TREATABILITY STUDY WORK PLAN FOR ZERO  
VALENCE IRON CONTINUOUS REACTIVE WALL  
AT THE ASH LANDFILL

CONTRACT NO. DACA87-92-D-0022  
MODIFICATION B TO DELIVERY ORDER NO. 31

FEBRUARY 1999

G - Response to EPA/NYSDEC Comments

**FIGURE 1**  
ASH LANDFILL SITE MAP WITH VOLATILE ORGANICS PLUME: POST-REMOVAL ACTION CONDITIONS

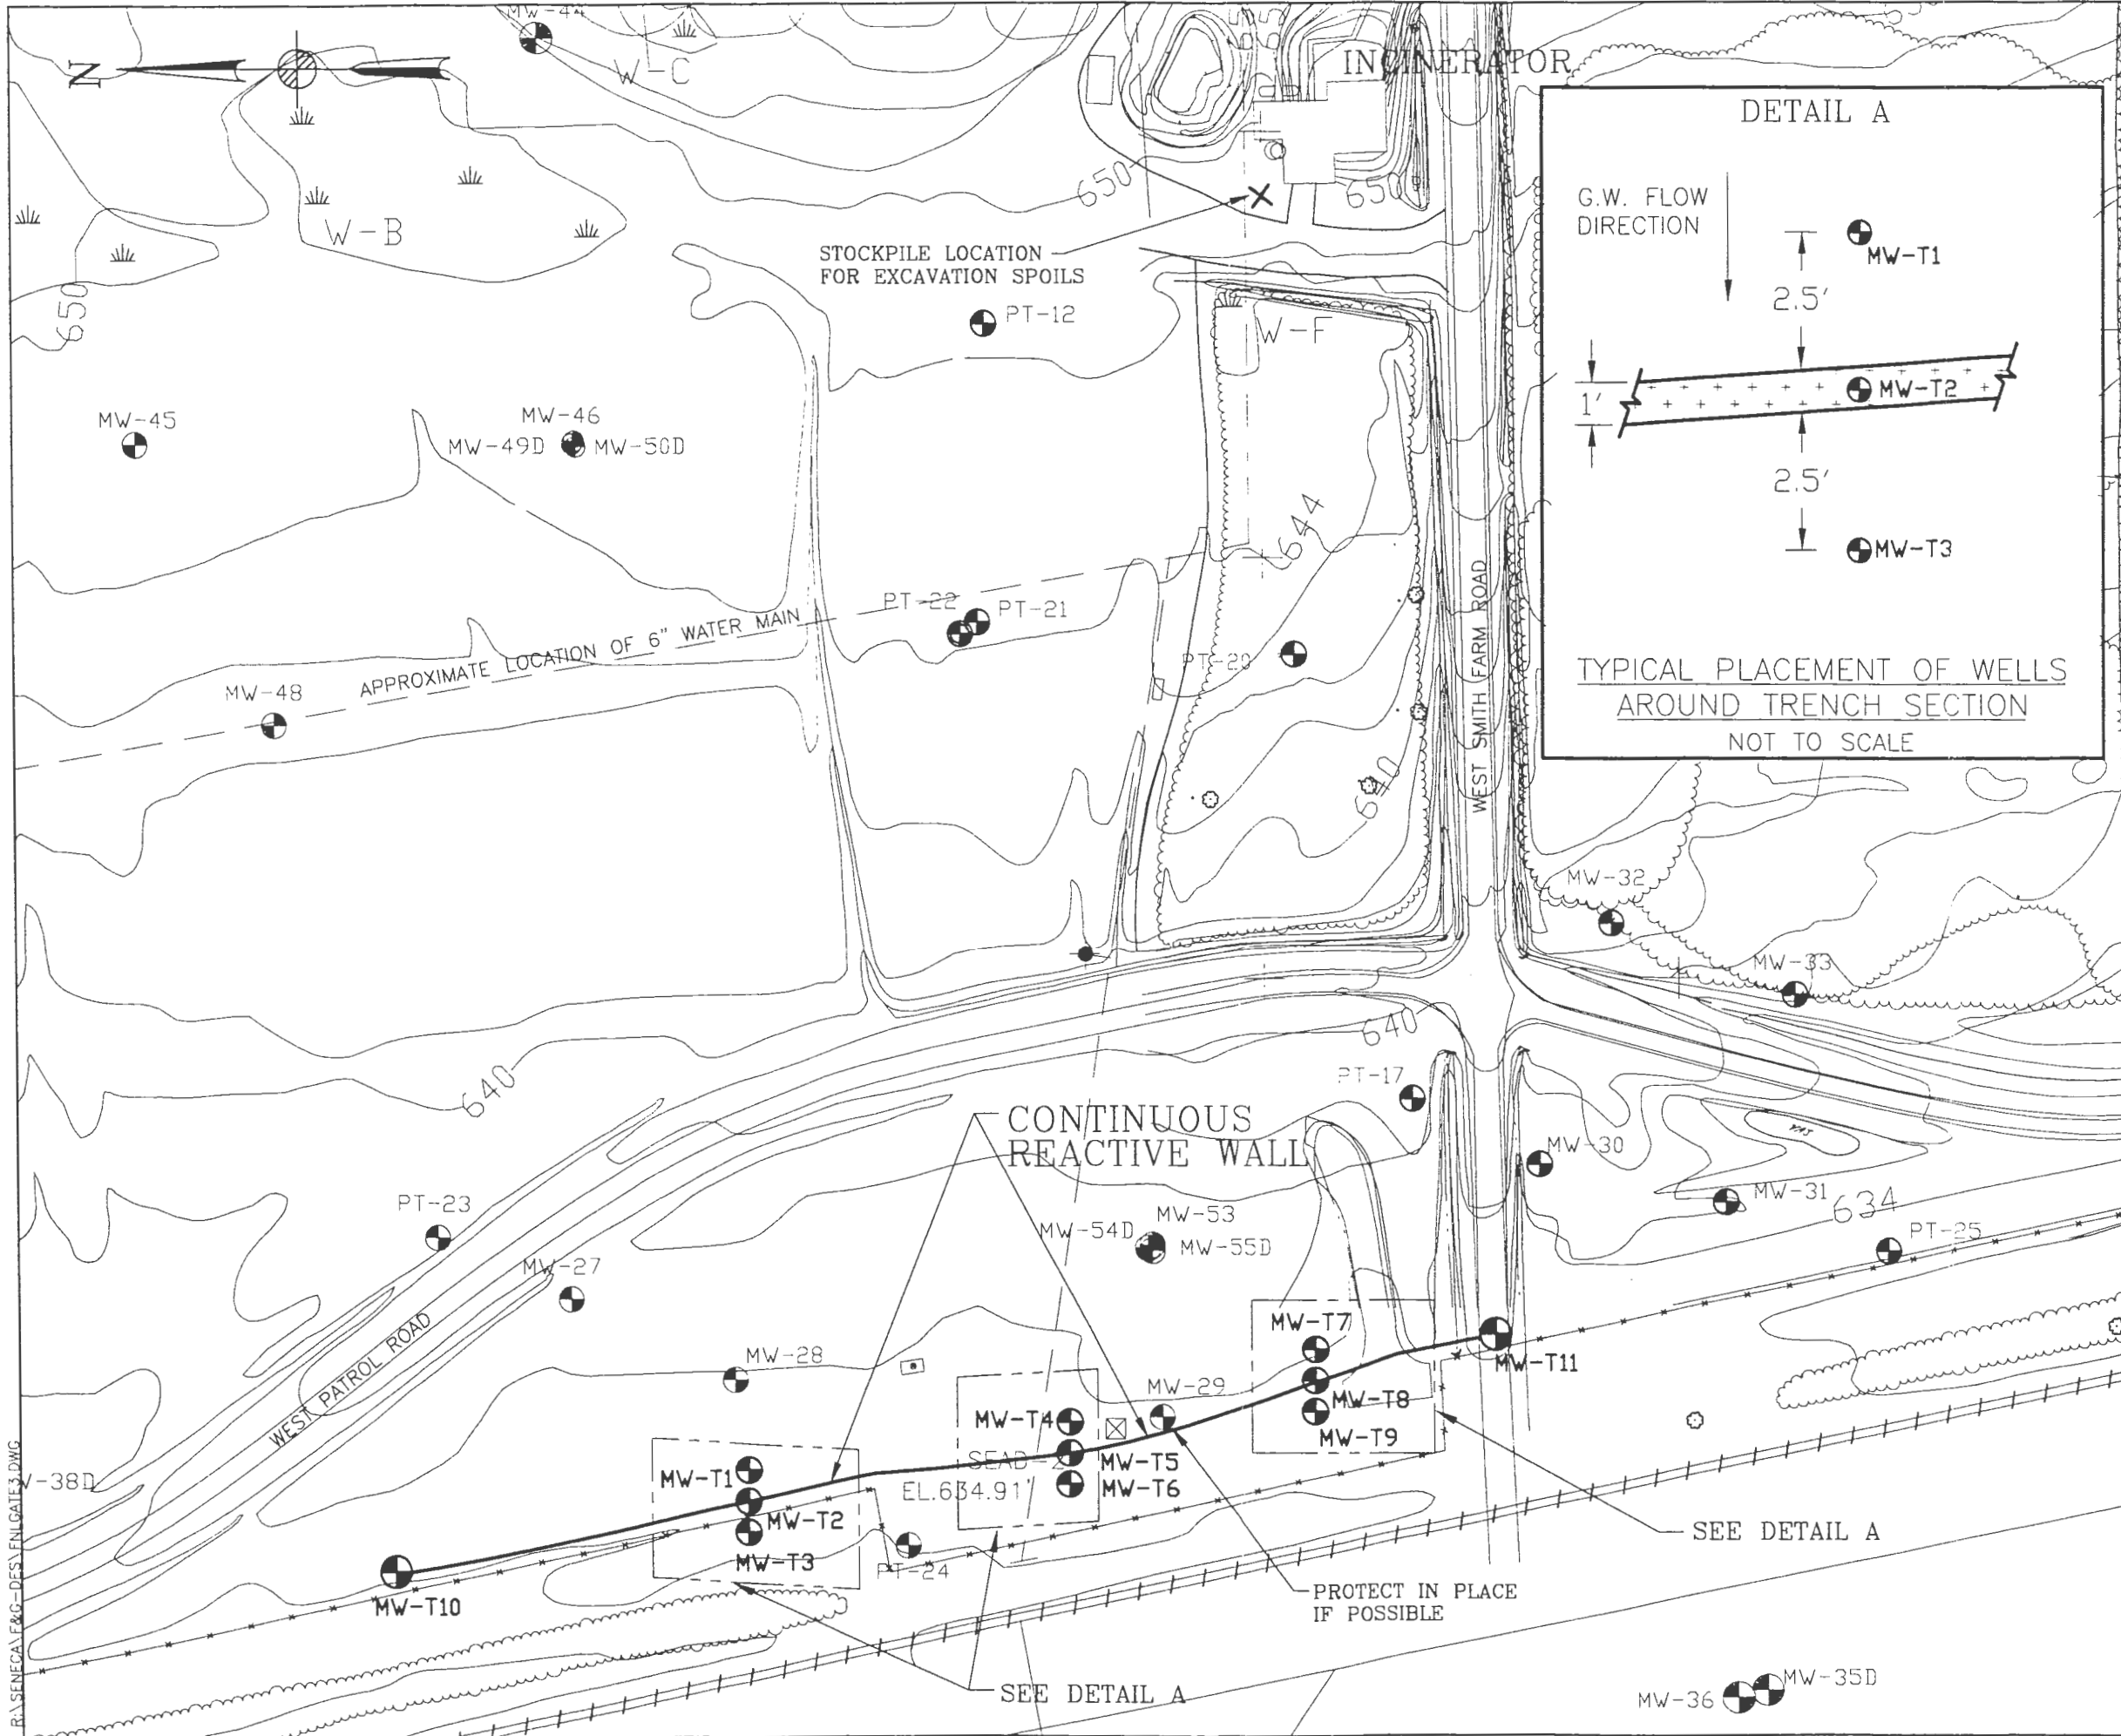
**Page 4, Section 2.3:** The text in this section states that MW-44 is located in the source area, however, a review of Figure 1 shows that there is no MW-44 in the plume, but there is a MW-44A. Text should be added to the document explaining which well is being discussed. The text in this paragraph also states that VOCs range from 10 ug/L to 100 ug/L; however, a review of Figure 1 shows a maximum concentration of 157 ug/L. The text should be corrected to reflect this maximum concentration.

**Page 7, Section 5.1, p2:** The purpose of MW-T8, i.e., to monitor for migration of contamination around the reactive wall, will be compromised because the well is located within the plume which is shown on Figure 1. Based on this, the wall should be extended further to the south, and should extend to a point almost directly west of monitoring well MW-30.

**Figure 1:** The reactive wall presented in this figure does not extend through the width of the plume, the wall should be extended to the south to capture and treat the plume.

**Response:** Agreed. MW-44 was located in the source area before the removal action took place at the Ash Landfill. The concentrations referenced in this section from MW-44 were detected prior to the removal action. Since MW-44 was located in the source area which was removed, MW-44 was removed and later replaced with MW-44A in the same location. The text has been modified to clarify that MW-44, the monitoring well from which the referenced data were collected, was located where MW-44A currently exists in Figure 1.

**Response:** The plume contour lines on Figure 1 may not accurately reflect the southern extent of the plume due to the presence of West Smith Farm Road. Contour lines indicate estimated concentrations based on the groundwater monitoring data shown and do not take into account the physical barrier that West Smith Farm Road may be providing as well as the topographic high point of competent shale which was observed to occur near this road during construction (based on trench bottom topography - see Figure G-1 attached). As we discussed during our conference call on December 8, 1998, except for MW-30, there is no evidence that the plume has migrated across this road. As USEPA pointed out, there have been occasional detections of TCE in MW-30 at concentrations hovering above the detection limit and below NYSDEC GA Standards. These detections have not been consistent. Because we are not convinced that the plume extends across the road, it was decided not to extend the wall across this road. Monitoring well MW-T11 (previously called MW-T8 in the earlier version of the treatability study work plan) will be located in the road at the southern end of the trench. If chlorinated solvents are detected in this well, the final remedy at the site will need to address this extension of the plume. However, for the purposes of this treatability study, monitoring from this well will occur before further action is taken.
